Application No.: 10/796,837

Amendments dated March 7, 2005

REMARKS

Title: Appliance Lifting Belt
Dkt# D04-04

Fig. 3

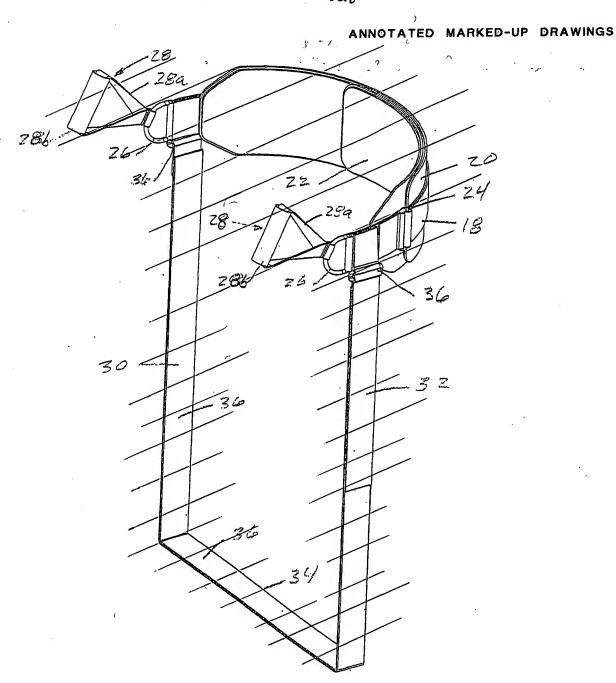
Informal Figure 1 of Sheet 1 of 6 sheets of "Annotated Marked-up Drawings" of informal drawings is replaced by Formal Figure 1 of Sheet 1 of 6 of the "Replacement Sheet" of Formal drawings. Informal Figure 2 of Sheet 2 of 6 sheets is replaced by Formal Figure 2 of Sheet 2 of 6 of the Formal drawings. Informal Figure 3 of Sheet 3 of 6 sheets is replaced by Formal Figure 3 of Sheet 3 of 6 of the Formal drawings. Informal Figure 4 of Sheet 4 of 6 sheets is replaced by Formal Figure 4 of Sheet 4 of 6 of the
